[Docket No. FAA-2013-0023; Directorate Identifier 96-CE-072-AD; Amendment 39-17688; AD 99-01-05 R1]

#### **Airworthiness Directives; Various Aircraft Equipped with Wing Lift Struts**

**99-01-05 R1 Various Aircraft:** Amendment 39-17688; Docket No. FAA-2013-0023; Directorate Identifier 96-CE-072-AD.

Figure 1

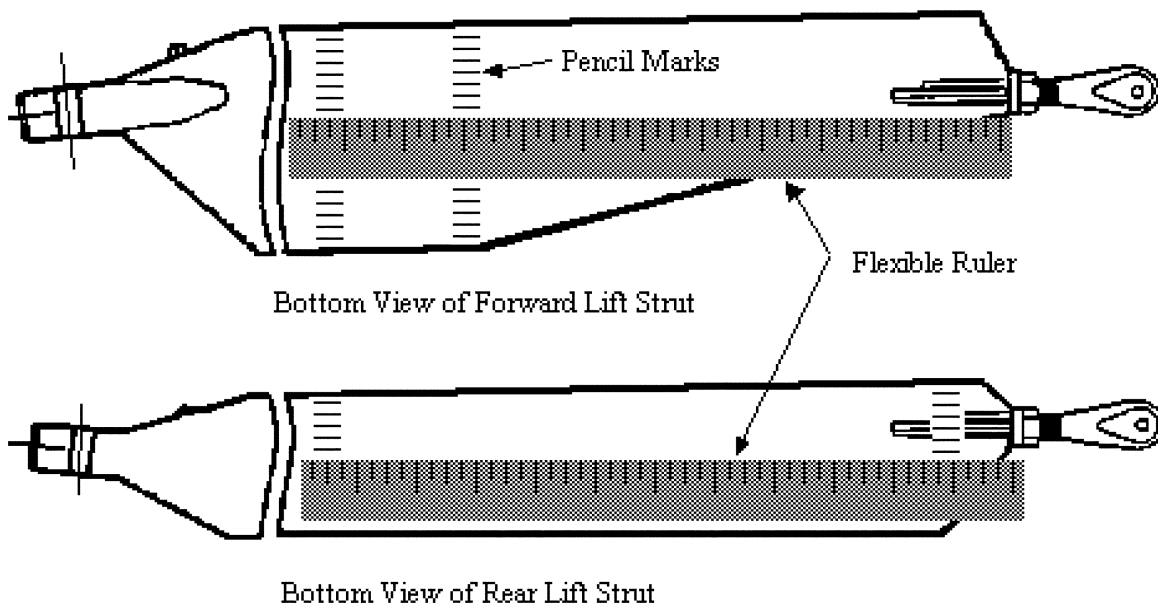
2. Using a flexible ruler, draw a 1/4-inch grid on the surface of the first 11 inches from the lower end of the strut as shown in Piper MSB No. 528D, dated October 19, 1990, or Piper MSB No. 910A, dated October 10, 1989, as applicable. This can be done using a soft (#2) pencil and should be done on both faces of the strut. As an alternative to drawing a complete grid, make two rows of marks spaced every 1/4-inch across the width of the strut. One row of marks should be about 11 inches from the lower end of the strut, and the second row should be several inches away where the strut starts to narrow. Lay the flexible ruler between respective tick marks of the two rows and use tape or a rubber band to keep the ruler in place. See Figure 1.
